Booth Street

Fire Safety Strategy

RIBA Stage 2

Doc ref: BST-HYD-XX-XX-RP-FE-0001

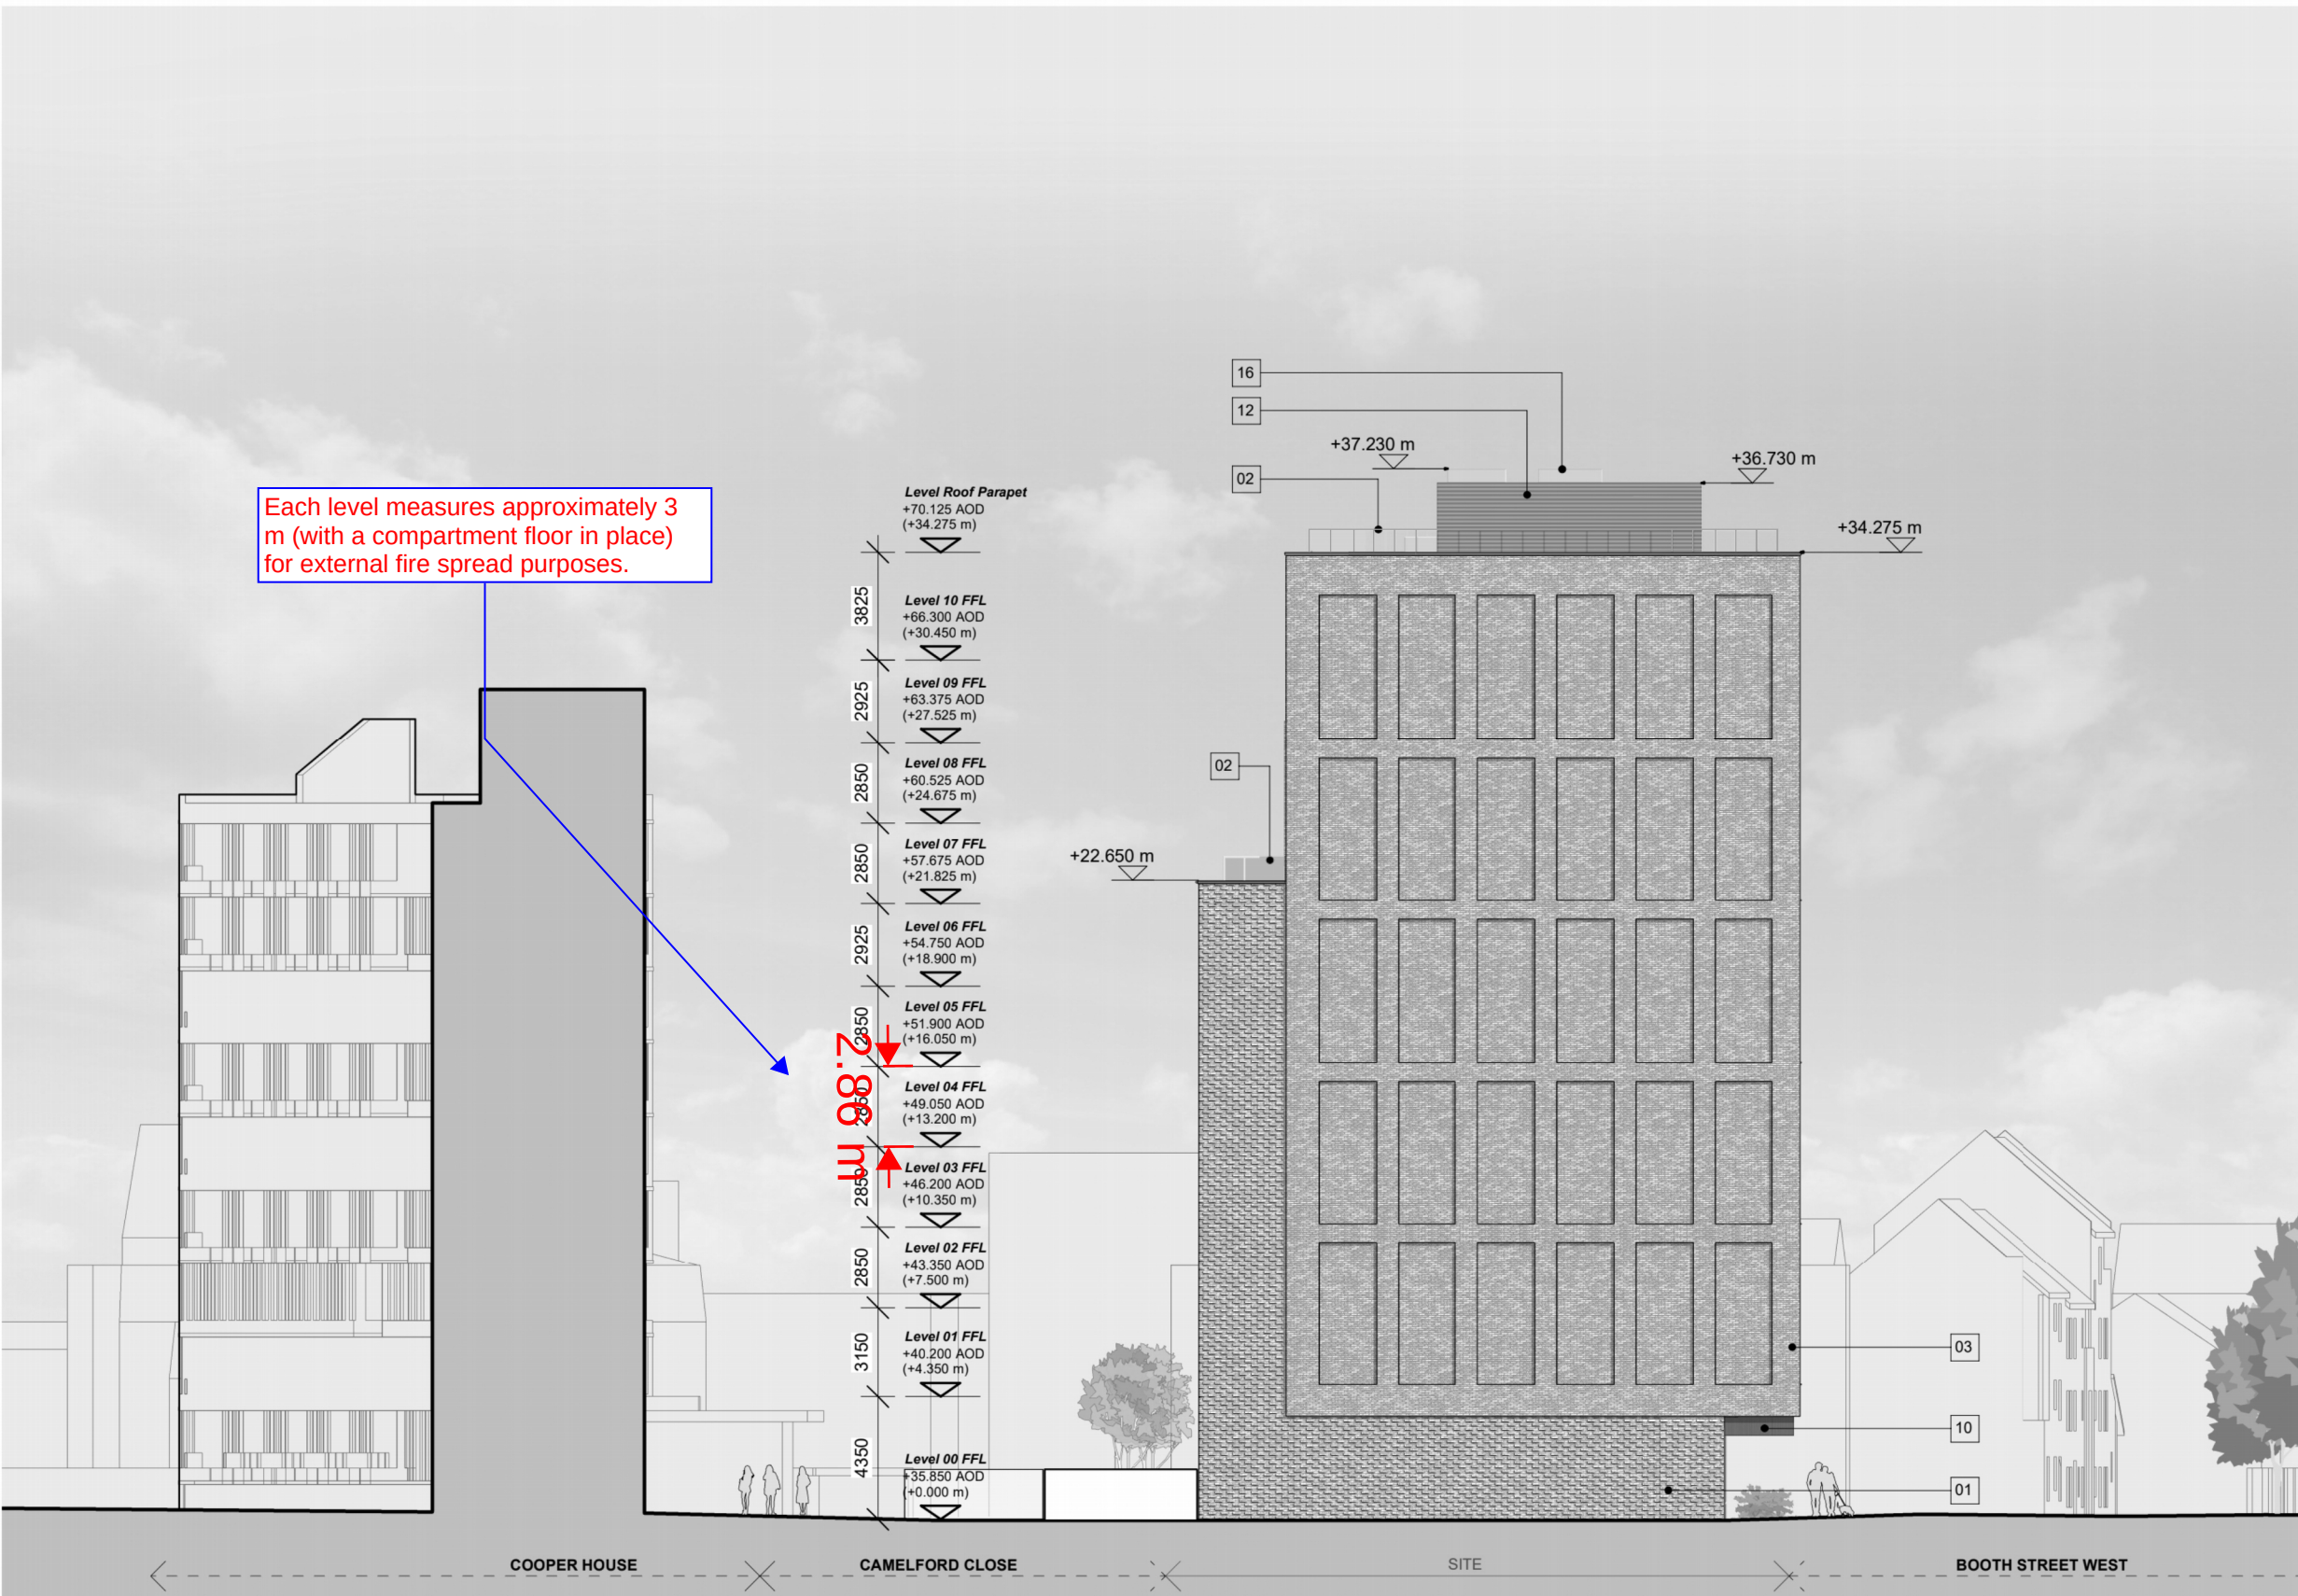
Each level measures approximately 3 m (with a compartment floor in place) for external fire spread purposes.
